Access Compliance Report

Public Rights-of-Way

(Curb Ramps)

Intersection ID: 10021978	Main Street: BROOKSVALE_ST	Cross Street: N/A	Location: SE
ADA ID: E7AD4A2EBB2	Ramp Type: Perp	Initial Pass/Fail: Fail	Overall Compliance: No
Severity Score: 13.75			
Codes/Mitigation Info/Possible Solution		Field Measurements/Component Compliance

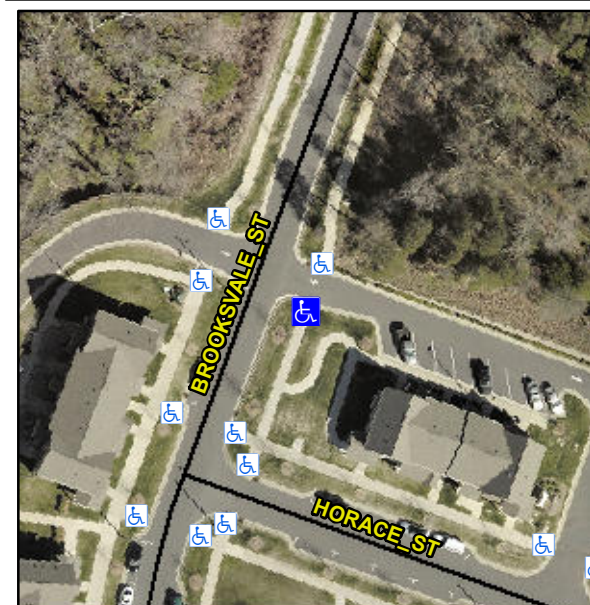
Not Found, R304.2.2

Compliance	Description	Data	Compliance	Description	Data
N/A	Ramp Length (in)	67.0	No	Ramp Slope (%)	10.1
Yes	Ramp Width (in)	71.0	Yes	Ramp XSlope (%)	2.4
N/A	Flare Type LT	N/A	N/A	Flare Type RT	N/A
N/A	Flare Slope LT (%)	N/A	N/A	Flare Slope RT (%)	N/A
N/A	Flare Traversable LT?	N/A	N/A	Flare Traversable RT?	N/A
N/A	Landing Length (in)	N/A	N/A	DWS Provided?	N/A
N/A	Landing Width (in)	N/A	N/A	DWS Contrast?	N/A
N/A	Landing Slope (%)	N/A	N/A	DWS Length (in)	N/A
N/A	Landing X Slope (%)	N/A	N/A	DWS Full Width?	N/A
N/A	Landing Curb? (Y/N)	N/A	N/A	DWS Offset (in)	N/A
N/A	Shared Landing?	N/A			
N/A	Gutter Ponding?	N/A	N/A	Gutter Slope (%)	N/A
N/A	Gutter Lip Ht (in)	N/A	N/A	Gutter X Slope (%)	N/A
N/A	Painted X Walk1?	No	N/A	Painted X Walk2?	N/A
	X Walk 1 Direction	To NE		X Walk 2 Direction	N/A
N/A	X Walk 1 Width (in)	N/A	N/A	X Walk 2 Width (in)	N/A
	X Walk 1 Slope (%)	1.9		X Walk 2 Slope (%)	N/A
	X Walk 1 X Slope (%)	4.3		X Walk 2 X Slope (%)	N/A

Remove & Replace Entire Ramp.
